## **Head Royce School Planned Unit Development Permit (PUD) Project**

### **Response to Comments / Final Environmental Impact Report**

October 2022

Lead Agency:  
City of Oakland

**Figure 1**  
Loop Road Alignment with and without Easement on Adjacent Ability Now Property

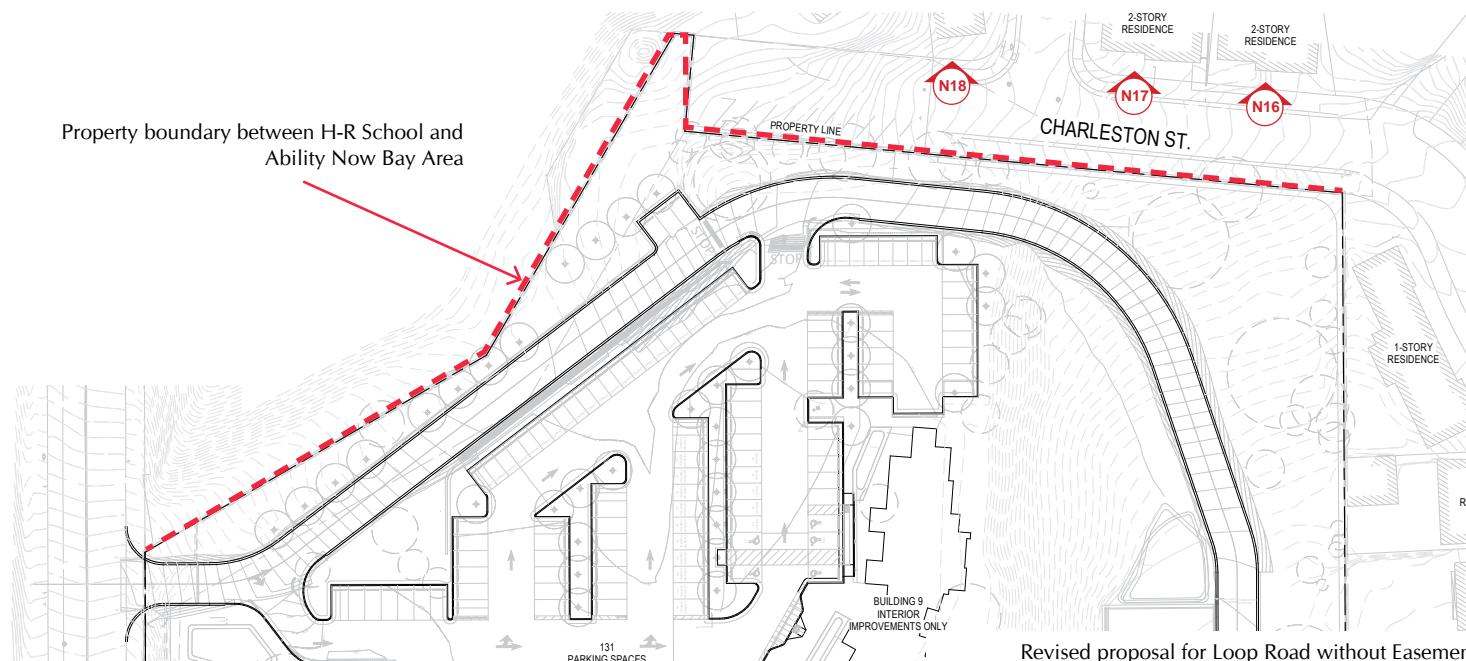
The original Project included a portion of a separate property at 4500 Lincoln Avenue (Assessor’s Parcel # 29-1009-10-5). This separate property is owned by a different entity (the non-profit Ability Now Bay Area). Head-Royce currently has a lease agreement with Ability Now Bay Area for non-exclusive use of an existing playfield on this separate property, and the School’s current use of this property is subject to prior conditions of approval pursuant to a 2018 amendment to the Head-Royce PUD permit. No change to this current condition for use of the playfield was proposed under the original Project, nor is any change to this condition now proposed. The original Project had also proposed/anticipated obtaining an easement from Ability Now Bay Area for use of a 15-foot wide strip of land on the Ability Now property along the eastern (uphill) boundary of the proposed South Campus. This proposed/anticipated easement was intended to accommodate a portion of the proposed Loop Road.

The School is no longer pursuing this easement from Ability Now Bay Area, and the Project site no longer includes a proposed easement on the 15-foot strip of land on the west side of the Ability Now Bay Area property that abuts the proposed South Campus. Without use of this easement, the alignment of the upper portion of the proposed Loop Road has shifted to the west (downhill), and the currently designed entrance to the Loop Road is about 30 feet further downhill on Lincoln Avenue than was assumed under the original Project. The Loop Road entrance has a longer right-angle dimension at its intersection with Lincoln, and the arc of the original Loop Road design has been straightened so that its alignment is fully within the former Lincoln property (see **Figure 2-1**). With this re-design, the Loop Road generally retains its original length, at approximately 1,610 linear feet from entrance to exit.

The re-designed Loop Road results in a slight decrease to the limits of grading for the Project, marginally reducing cut slope excavation (the anticipated 15-foot easement was located on a sloped portion of the Ability Now hillside), and eliminating the need for a retaining wall on the Ability Now property. It will not result in any changes in the number of trees to be removed, as no tree removal was originally contemplated on the Ability Now property. These changes would marginally reduce grading impacts as identified in the Draft EIR, but would not result in any new significant or more severe impacts not addressed in the Draft EIR and thus does not necessitate recirculation of any portions of the Draft EIR.

**Figure 3-1**  
**March 2022 Noise Monitoring Locations**

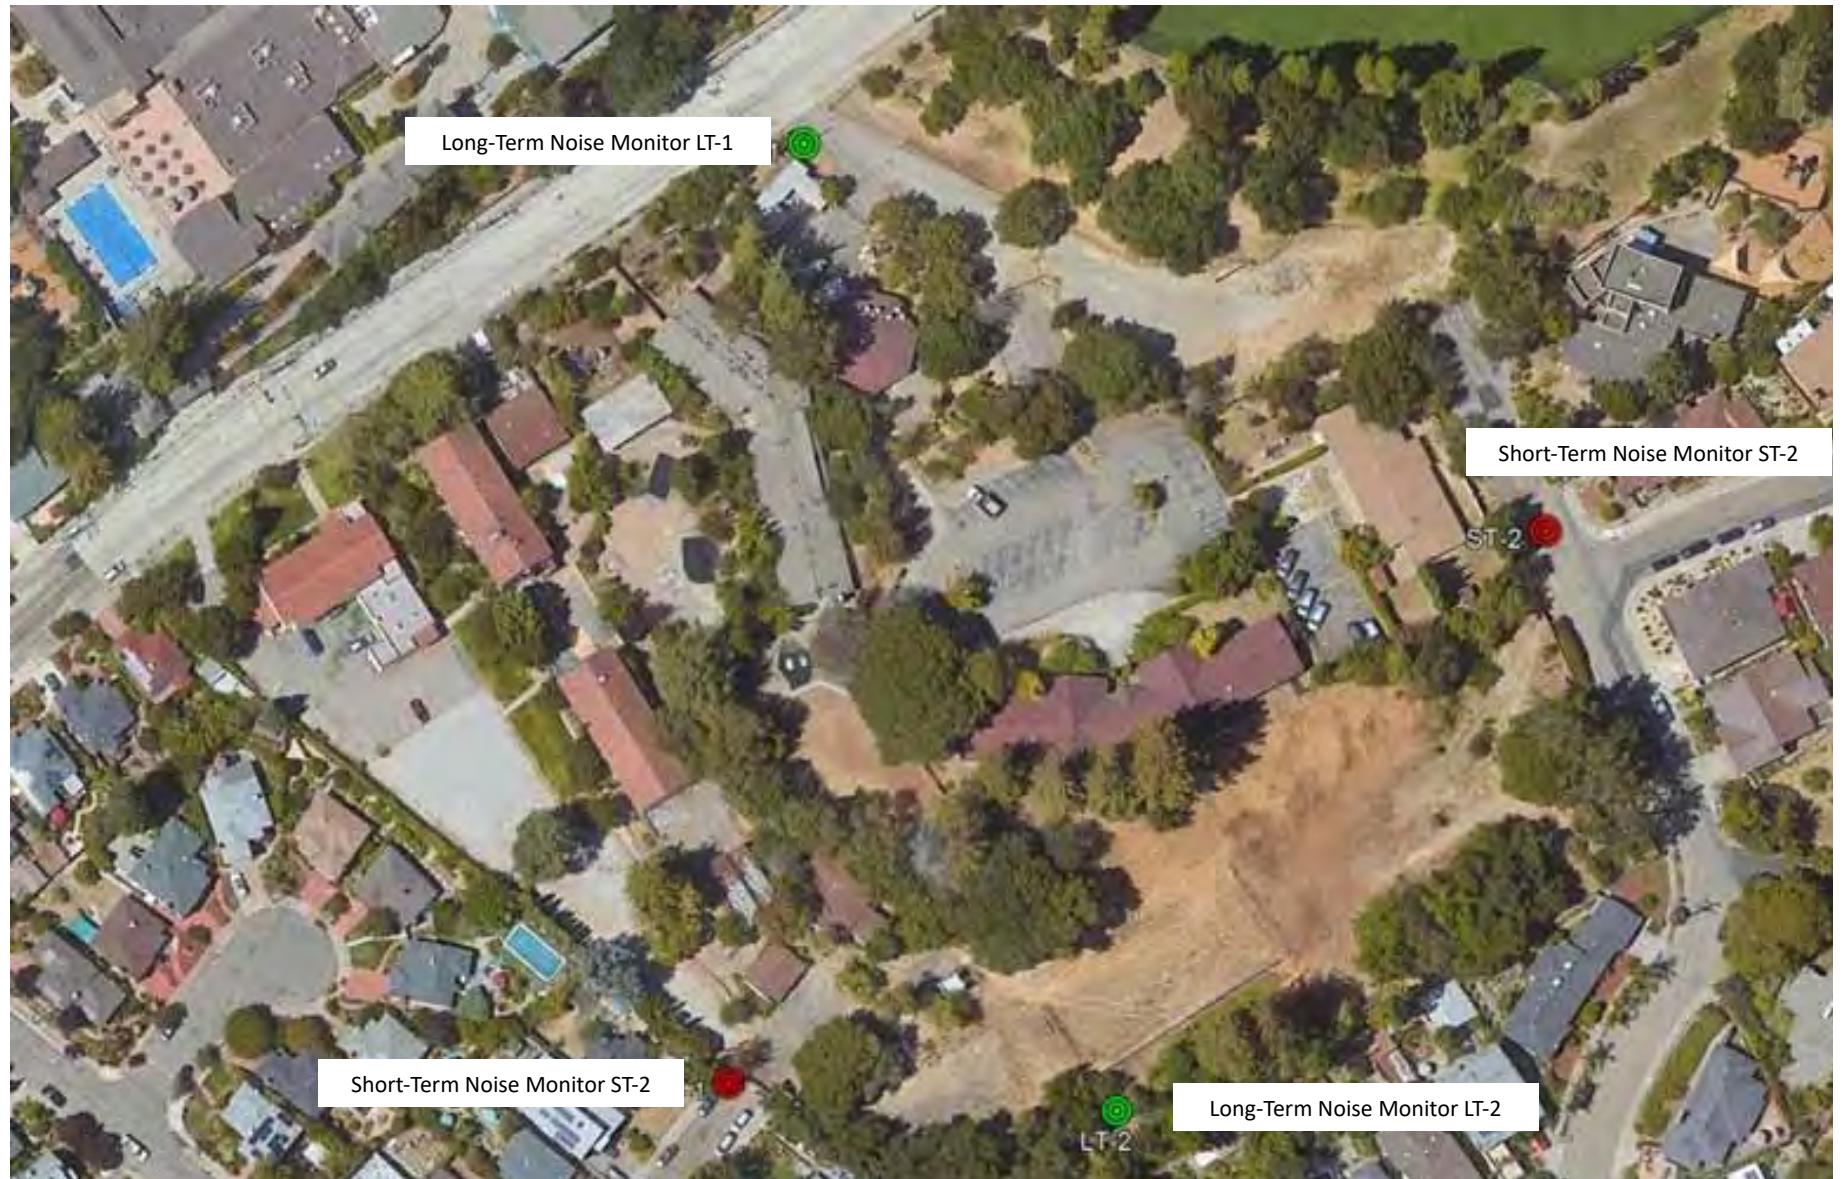
Long-term noise measurements LT-1 and LT-2 measured noise levels between Thursday, March 10, 2022 and Friday, March 11, 2022. The measurement location for LT-1 was at the northern corner of the Project site

along Lincoln Avenue, near the entrance to existing parking lots A and C. The measurement location for LT-2 was near the southeastern corner of the Project site at the fence line of an adjacent residential property in a relatively quiet area, away from local street traffic. These locations were selected to quantify the existing noise environment of the noise-sensitive uses nearest to the Project site (see **Figure 3-1**). Long-term noise measurement data is summarized in **Table 3-2**. The daily trends in noise levels at long-term noise measurement sites are shown in **Figure 3-2**.

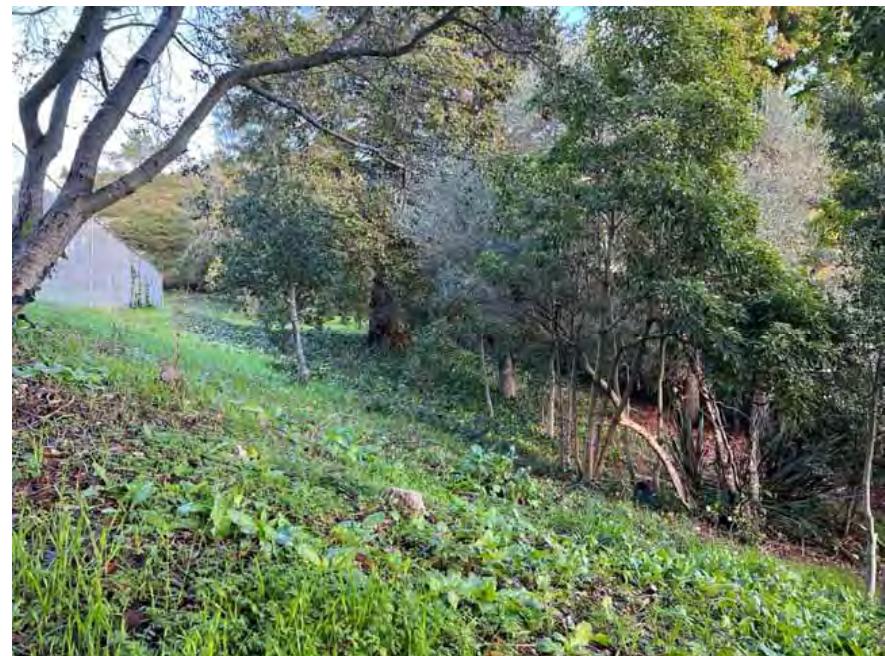
The DEIR does not provide sufficient detail for the grading plan to accommodate the loop road. Below are photos taken from East to West and West to East on the southern boundary of the property showing the substantial slope of the property in this corner. As drawn, the loop road is indicated to go between the existing sports field and southern perimeter fence, an area of steep slope. To have the road banked appropriately for the required 90 degree turn against such a slope will likely require a substantial retaining wall. The plans for such a wall, and the consequent impacts on the adjacent trees have not been adequately addressed.

Photo taken from West to East ~ road as drawn is to go in between the left hand fence and property boundary and plans say redwood tree will be preserved. Note the steep slope that will require substantial grading for a proper road. This is not adequately addressed in the DEIR.

As indicated in the Draft EIR (page 8-11), the portion of the site shown in this picture is an area of colluvium within a broad swale along the southerly site boundary that was partially buried by artificial fill. Pursuant to the August 2020 Rockridge Geotechnical and Geological Evaluation (Appendix 8F), the slope just uphill of this location is to be partially reconstructed to mitigate the potential for future slope instability under static and seismic conditions, during construction of the proposed future site improvements (i.e., the Loop Road). As shown on Figure 8-10 of the Draft EIR, the portion of the Loop Road that would be constructed where this picture was taken would include about 2 to 4 feet of fill, with a 4-foot retaining wall on the downhill side of the road and a 3-foot retaining wall on the uphill side of the road.

The redwood trees shown in this picture are identified on Figure 6-5 of the Draft EIR as Trees #7487 and #7488. These trees are on the downhill side of the Loop Road, and their SRZ is not within the limits of

As shown on Figure 8-11 of the Draft EIR, the portion of the Loop Road to be constructed in the area where this picture was taken is proposed to include more substantial new fill of 6 to 8 feet, where the roadway currently curves up from the lower swale along the southerly site boundary. As shown on Figure 8-10 of the Draft EIR, this fill is to be held in place with an 8-foot retaining wall on the downhill side of the road.

As shown on Figure 6-7 of the Draft EIR, the trees on the downhill side of the road construction are expected to be retained, but the trees on the uphill side of the road (for example the Italian stone pine and the olive tree shown on the right side of this picture) are proposed to be removed.

Figure 3-11  
Proposed South Campus Master Plan

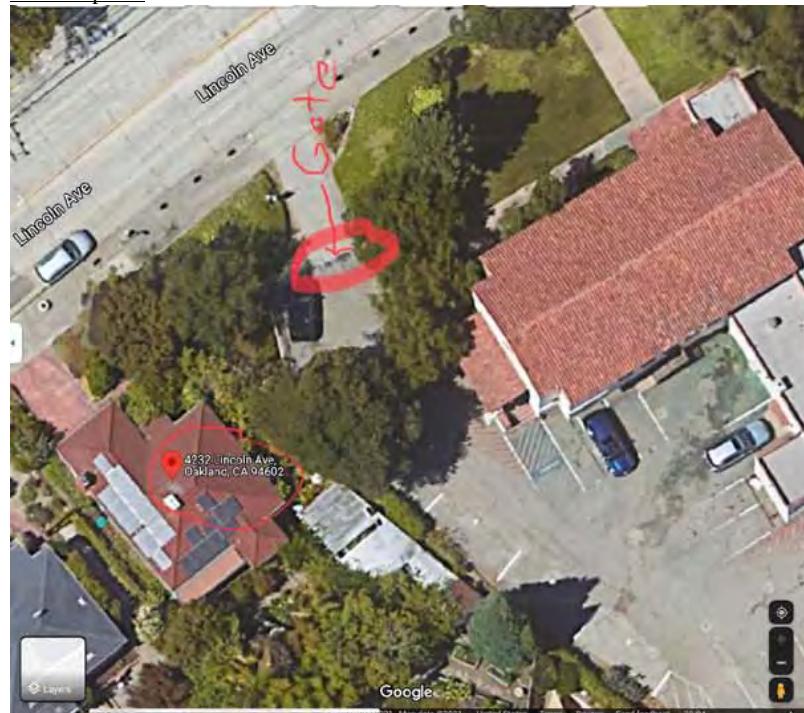
(Note: Approximations of my exact measurements can also be obtained by using the scaled drawing provided DEIR Fig. 3-5. For example, using the scale provided in Fig. 3-5 it is easy to ascertain that the distance from our home to Blg 0 is close to 50 feet, which is more than twice the distance from our home to the proposed perimeter Loop Road). The sound levels referenced in the EIR for a ~50 feet distance are significantly less than my own sound meter measurements. My measurements are over 60 dB. Whereas the studies used for the DEIR appear to have used no noise measurements made at any of the existing residential property boundaries around the South Campus where most noise impacts will occur. The data in the EIR needs to be based accurate distances, from noise emitter to receiver, and based on actual on-site testing and measurement results. Instead, the traffic study for the DEIR has relied only on overly generalized “Federal Highway Administration’s Traffic Noise Model (TNM)” data for cars traveling 20 mph, and apparently without even factoring in project site specific topography (the TNM input parameters were not provided).

the proposed development would have large gatherings of 100 people outside Blg 0 (DEIR pg. 13-37) within less than 100 feet of our bedroom windows (distance based on my own measurements and supported by DEIR Fig. 3-5 that provides scale drawings, in conjunction with Fig. 4-7, that shows exact location of terrace outside Blg 0). The information provided in the EIR should be based on comparisons of the actual current noise impacts on our home (location R1, DEIR figure 13-6) from a max. 62 car parking lot (Lot D) to the future noise impact of 770 cars traveling on the loop road within 50 feet of our home concurrent with future noise impact of large gatherings outside Blg. 0 (“50 feet” distance is referenced on DEIR pg. 13-40, although my own measurements show the internal loop road would be less than 30 feet from our home, also supported by scaled drawing in DEIR Fig. 3-5).

Plans for the internal Loop Road include a Vehicular Gate (DEIR figure 3-11) that is much closer to our home / bedrooms than the existing non-mechanical vehicular gate (refer to the attached satellite photo indicating location of existing non-mechanical “gate”). The Noise chapter of the EIR does not address the significant potential noise impacts on our property & home from the planned usage of a mechanical gate and also from placing that gate much closer to our home than the existing manual gate.

Satellite photo showing location of the greenhouse (labeled as 1), lathe house (labeled as 2) and shed (labeled as 3):

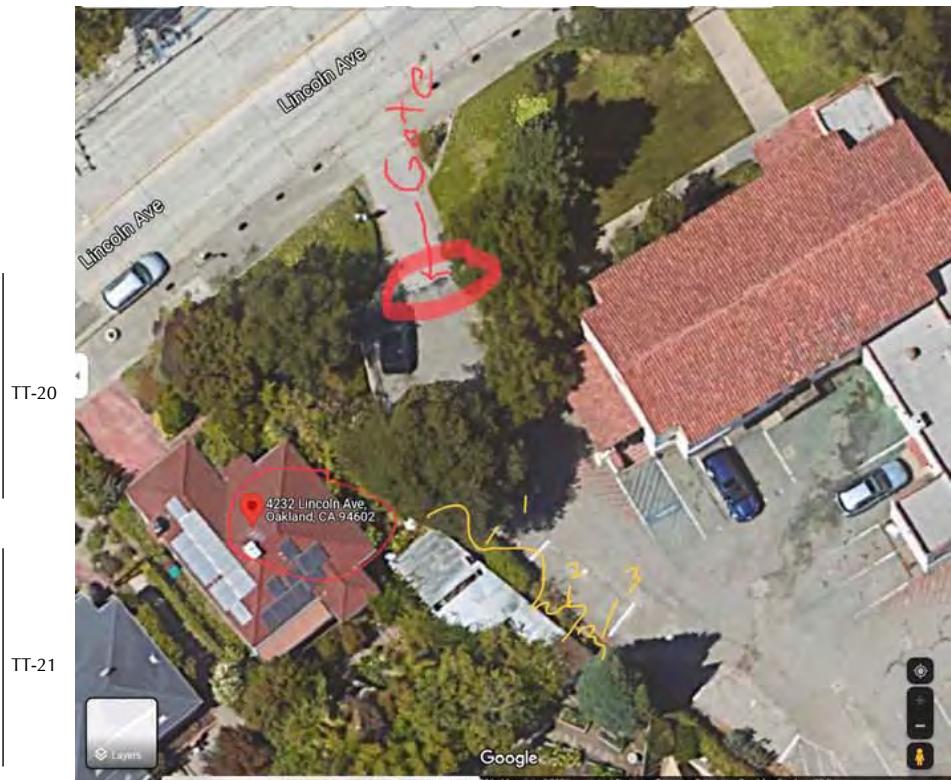
(D) The following pre-existing (from original 1941 construction) structures are located along the property line between my property and the proposed Head-Royce South Campus property: back wall of greenhouse structure with a fireplace, side wall of shed, and back side of lathe house. The EIR should provide information about the impacts of a sound wall along our property line to the pre-existing structures that are along the property line, including how it would impact our ability to access, maintain, repair and preserve those structures. The EIR should also assess how the sound barrier wall would impact the ability for the lathe house structure to continue to fulfill the purposes for which it was designed, which includes providing specific levels of light and air circulation for the types of plants kept inside the lathe house.

Figure 11-4  
Preliminary Stormwater Control, Drainage Plan

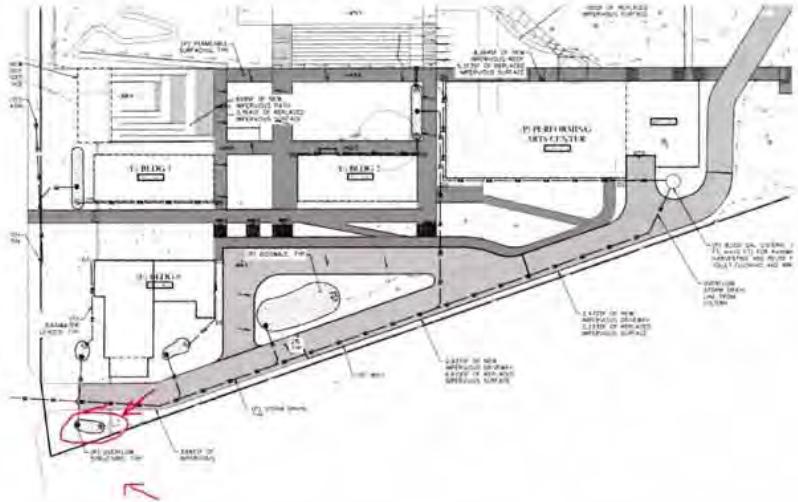
The following copy of DEIR Figure 11-4 shows the location of a bioswale (circled in red) that would be created within a few feet of the property line and within 15 feet of the of our home.
